**Boorley Green Gateway
Winchester Road
Botley
Southampton
SO32 2UA**

Our Ref: CP/RP/0000/6663

Planning Ref: F/19/86233

BOORLEY GREEN GATEWAY - DRAINAGE SUDS VERIFICATION REPORT

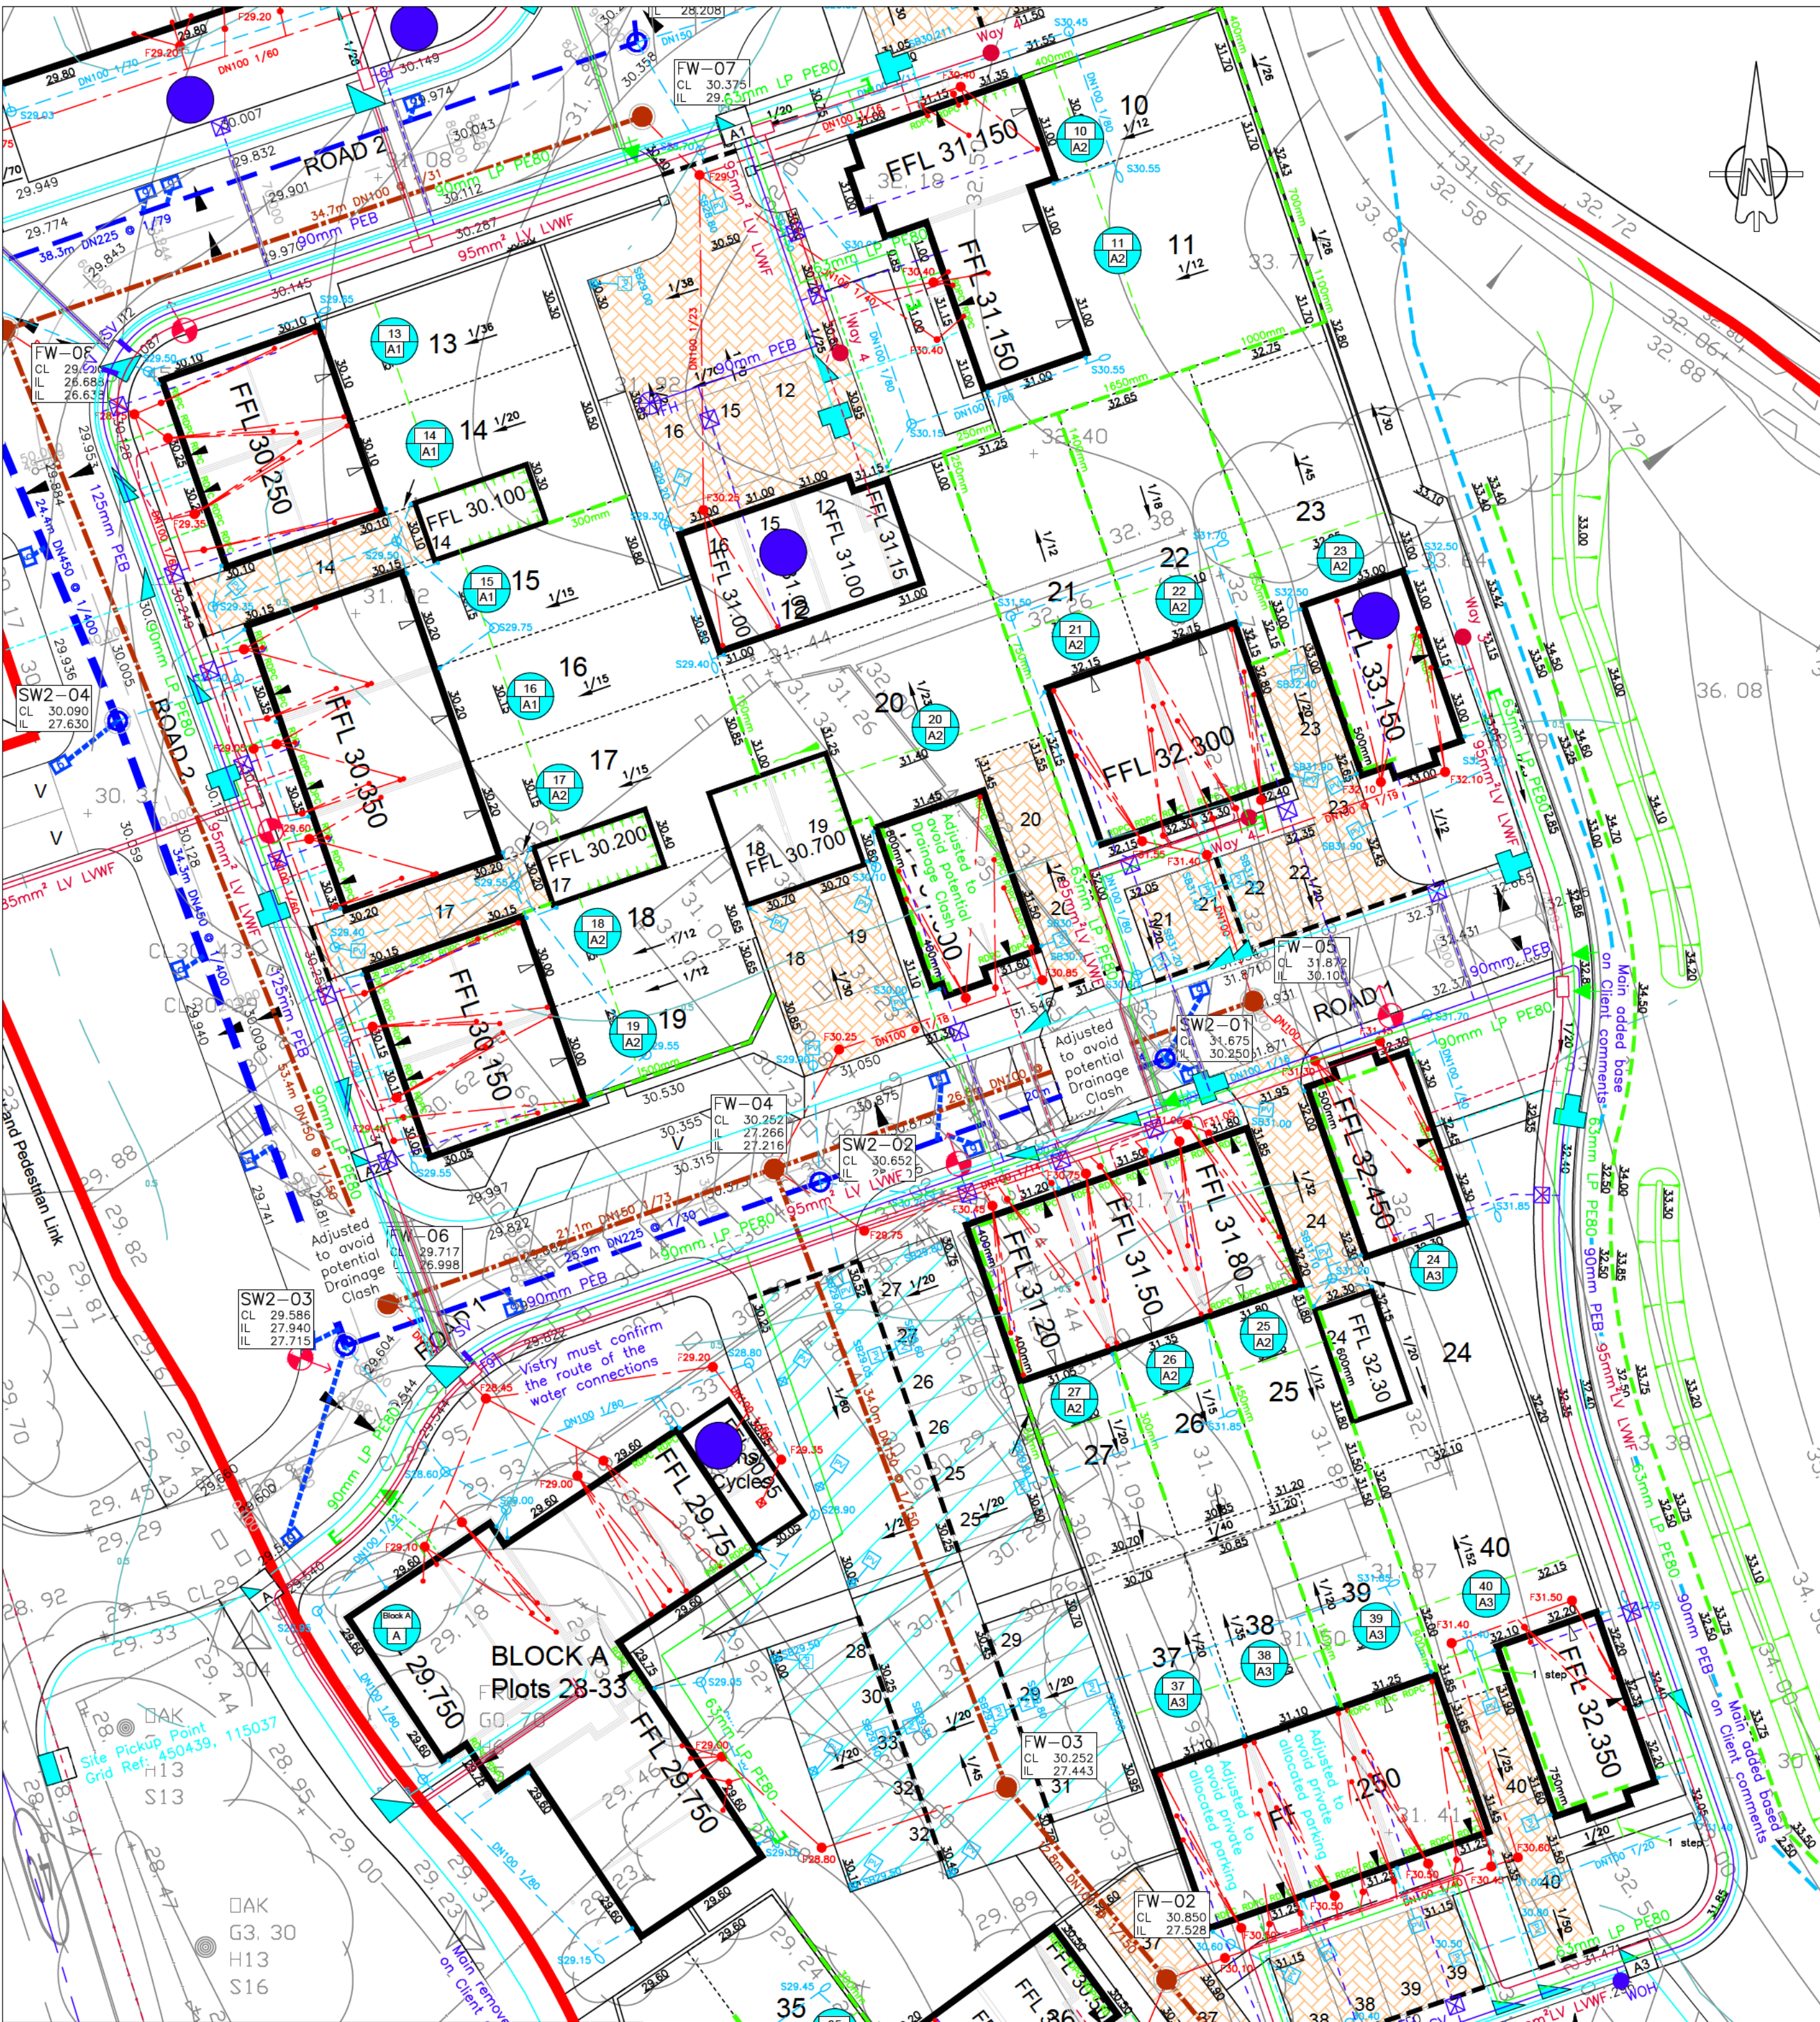
- 4.15 The exception to this is SW1-09, which has been constructed approximately 8m further west within the carriageway than indicated on the engineering layout.

The exception to this is SW1-09, which has been constructed approximately 8m further west within the carriageway than indicated on the engineering layout.

Item No. 1	Insp. No. 1	Date 10/04/25	Time 11:07	Client's Job Ref .	Weather No Rain Or Snow	Pre Cleaned Yes	PLR SW2-03X
Operator A Fox		Vehicle YV21 BXM		Camera Crawler	Preset Length 0.80 m	Legal Status Highways Drainage	Alternative ID Not Specified

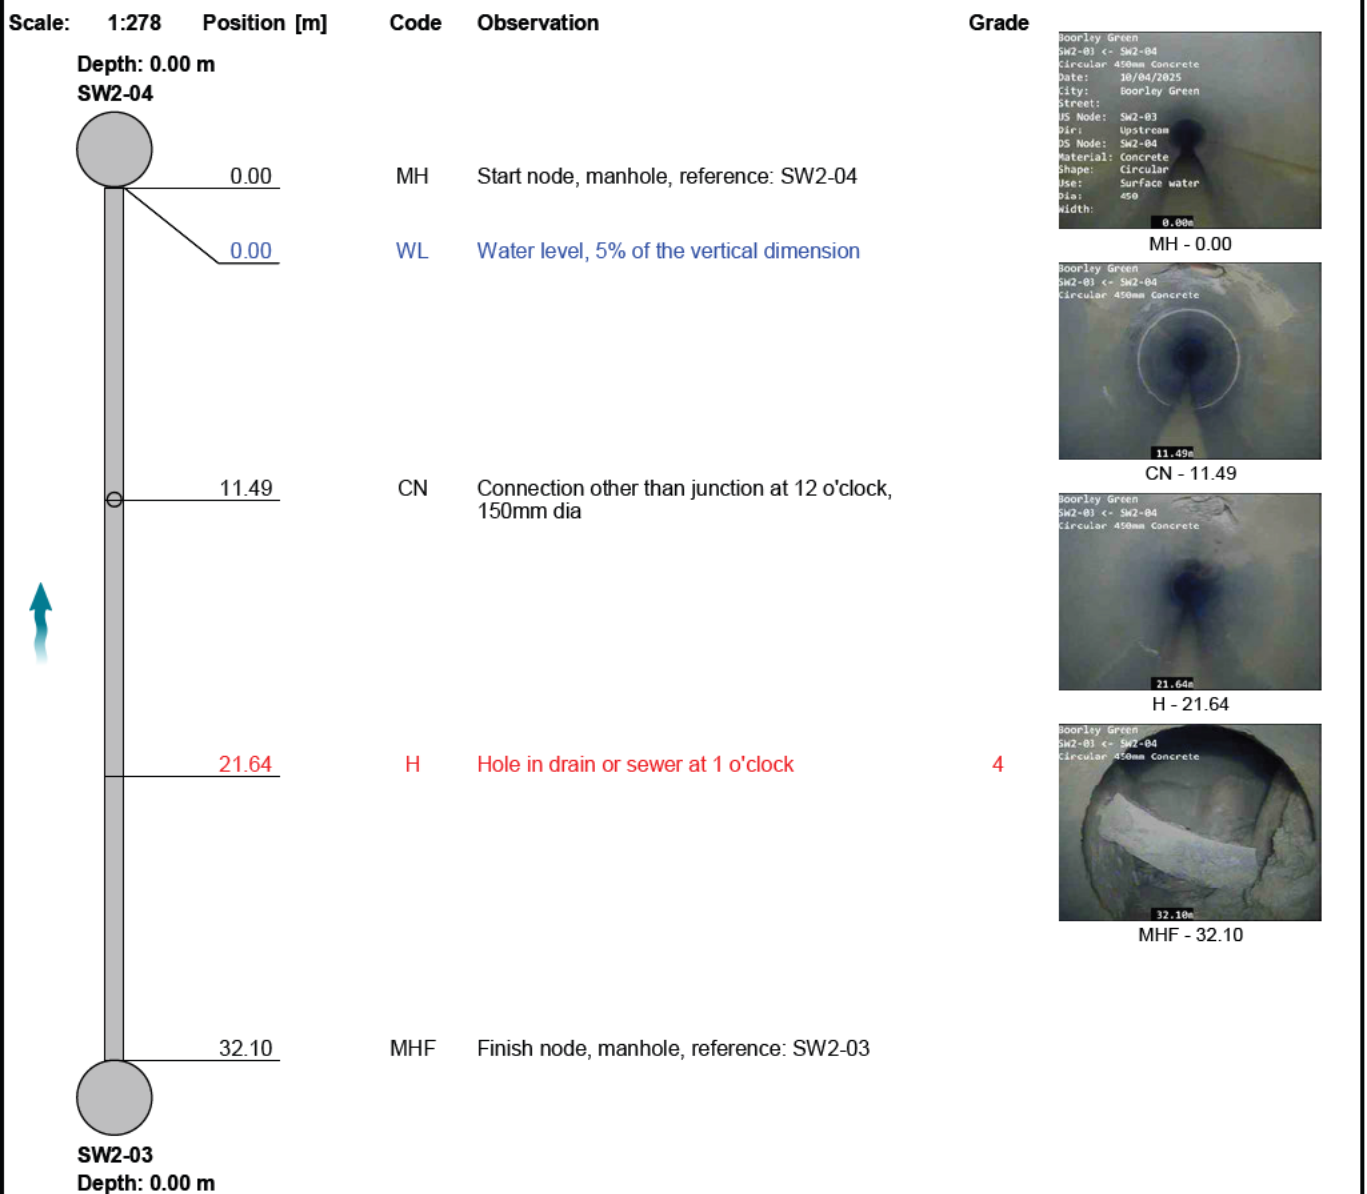
- SW2-04 to SW2-05 - No defects
- SW3-02 to SW2-05 - No defects
- SW3-01 to SW3-02 - No defects
- SW2-03 to SW2-04 – Grade 4 defect identified: hole in drain located at 21.64m.
The defect is positioned at the 1 o'clock orientation within the sewer and does not present an immediate operational concern, however, remedial repairs are recommended within the next six months.

Although not directly affecting the operation of the surface water drainage system, it is recommended that the defect identified between manholes SW2-03 and SW2-04 (Grade 4 defect comprising a hole in the drain at a recorded level of 21.64m) be repaired. Remedial works should be undertaken within the next six months to prevent potential deterioration of the asset and to maintain the long-term integrity and performance of the drainage network.
